Subject ► Change on motor housing and baffle plate

For Models ► 9027, 9027S, 9037, 9037S, 9029, 9029S, 9039 and 9039S (Disc Grinder)

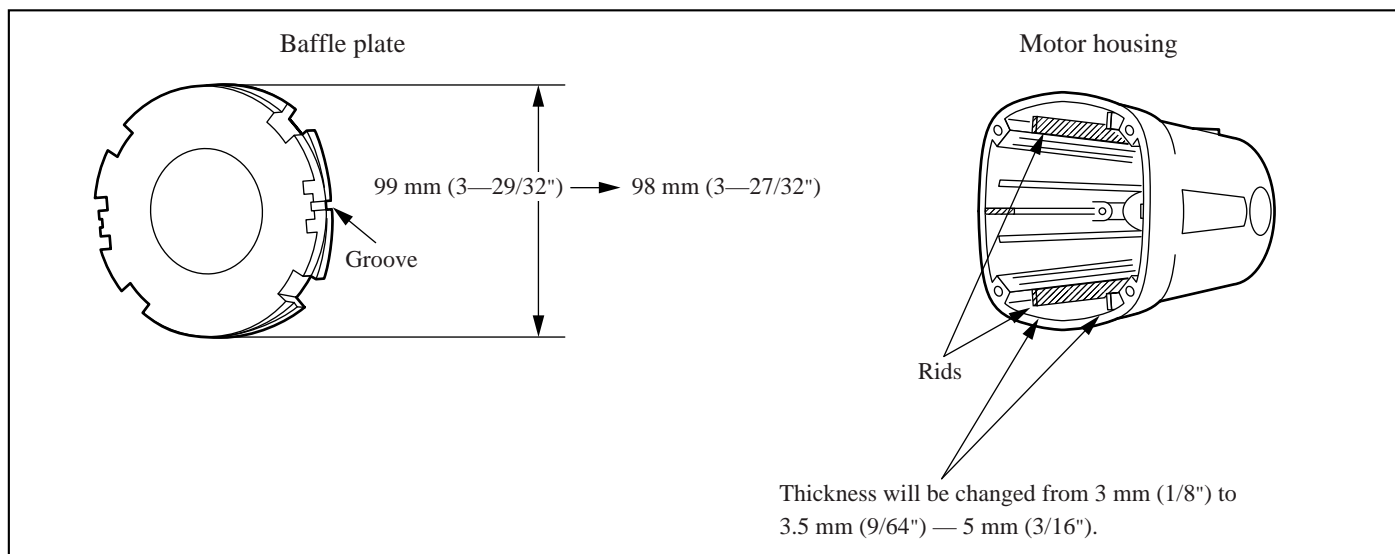
1. The motor housing will be reinforced as follows.
 - i) Ribs will be added.
 - ii) Its wall (black portion) will be thickened.
2. The baffle plate will be changed as follows.
 - i) Grooves will be added.
 - ii) Its diameter will be changed from 99 mm (3-29/32") to 98 mm (3-27/32").

Item No.	Current part		Q'ty	I/C	New part		Q'ty	Note
32	Motor housing assembly 125029-6		1	No	Motor housing assembly 125036-9		1	Interchangeable as a set
4	Baffle plate 414989-0		1	No	Baffle plate 415647-1		1
